Enclosure 4 to Long Mott Energy, LLC, Letter No. 2025-PLM-NRC-013

Long Mott Energy, LLC

PSAR Subsection 2.4.5, “Probable Maximum Surge and Seiche Flooding”

**Long Mott Generating Station
Preliminary Safety Analysis Report**

Figure 2.4.5-3
Distribution of Hurricane Central Pressure at Landfall for Hurricanes that Made Landfall on the Texas Gulf Coast

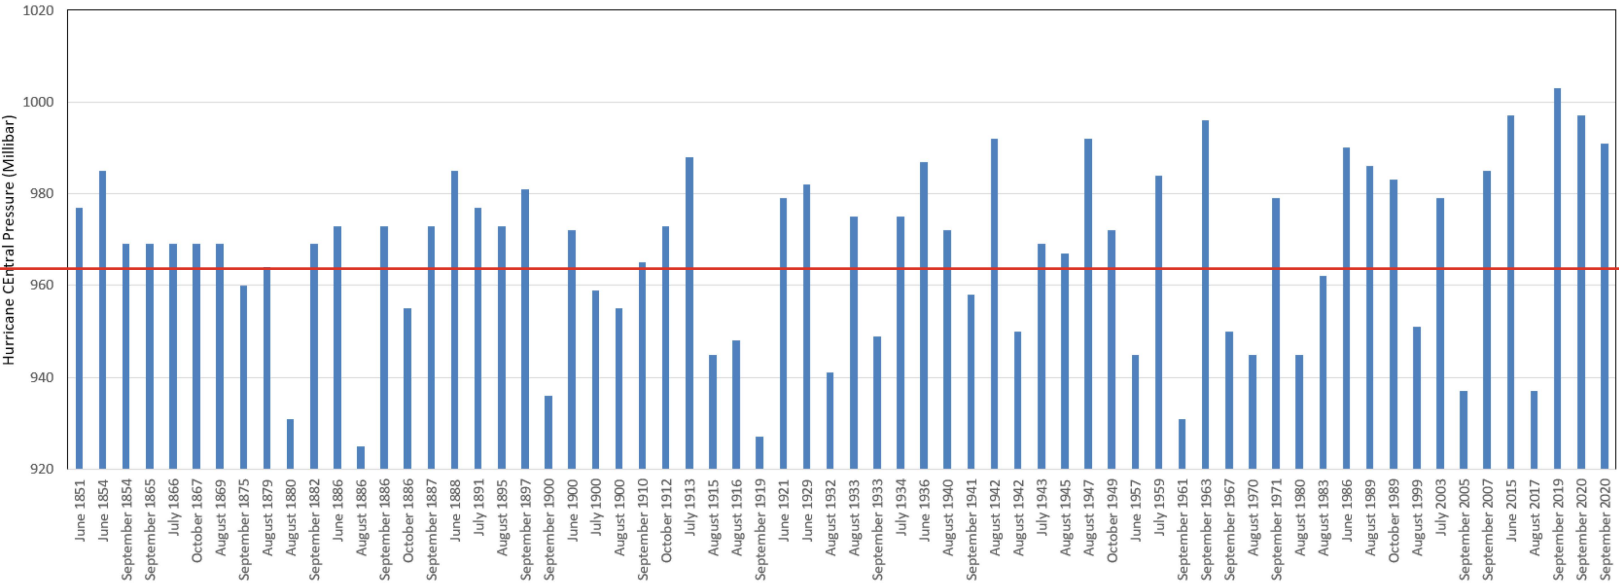
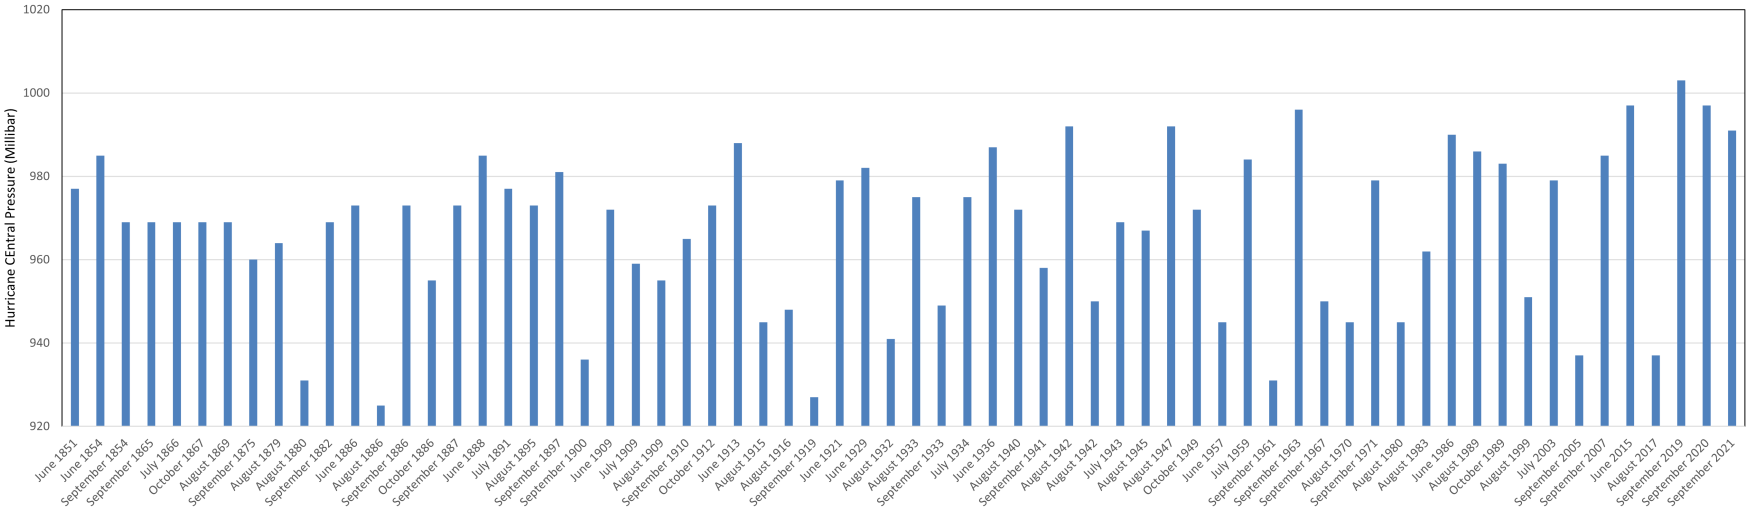
A list of hurricanes that made landfall on the Texas Gulf Coast from 1851 to 2023 is presented in Table 2.4.5-2 (Blake, et al. [2007-2011](#) and NOAA, 2024a). Figure 2.4.5-2 shows the tracks of all hurricanes in the Gulf of Mexico from 1851 to 2023 with intensities of Hurricane Category 1 and above on the Saffir-Simpson Hurricane Scale. Figure 2.4.5-3 shows the variation in the central pressures of the hurricanes tabulated in Table 2.4.5-2. As indicated in Table 2.4.5-2 and Figure 2.4.5-3, the August 1886 Indianola Hurricane was the most intense hurricane that affected the Texas Gulf Coast. The hurricane made landfall on the Calhoun County, Texas, coast near the LMGS site, as shown on Figure 2.4.5-2.
